BABCOCK • JONES & ASSOCIATES, INC.

Grading Plan Approved
as shown and/or noted
THOMAS P. GILL
Lake County Engineer
4/14 4/9/92
By _____ Date
SEE ATTACHED REVISED
PLAN.
APPROVED

Reviewed and Accepted _____
LAKE COUNTY GENERAL HEALTH DISTRICT
Date April 2 1982 *E. K. Hulse*
BY Nancy Niehus *APR 1982*

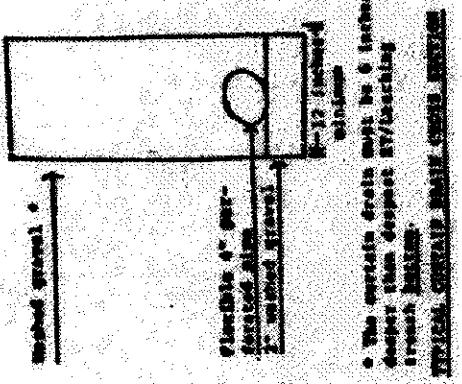
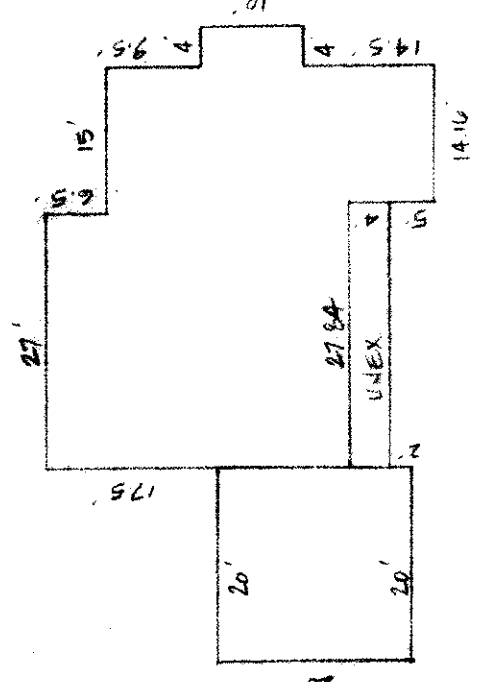
- 1) Road ditch must be deepened to accept the curtain drain outlet
- 2) E.T. lines may not exceed 18" deep
- 3) No permit issued until the ditch deepened and verified.

- A. To be brought to finished grade**
 1. Septic tank manhole covers
 2. Splitter box cover
 3. Distribution box cover
- B. No footer drains or downspouts to be discharged into septic tanks**
- C. All waste water to be discharged into septic tanks**

**LOW FLOID WATER
FIXTURES REQUIRED
ON ALL:
Shower Head
Toilet**
